Product Change Notice (PCN)

PCN Number: PCN-0455008R

Product(s) Affected: PJ-036BH-SMT-TR

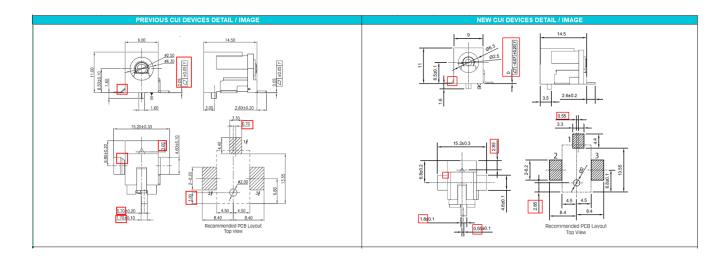
Description of Change: Product re-engineered for improved manufacturability and production yield. Coplanarity specifications changed. Shape of terminal 2 changed. Location and size of terminal 1 changed. Locating post PCB hole location changed. See image below for reference and check CUI Devices website for updated drawing. Cosmetic differences may be visible and not affect the form fit and function of the product.
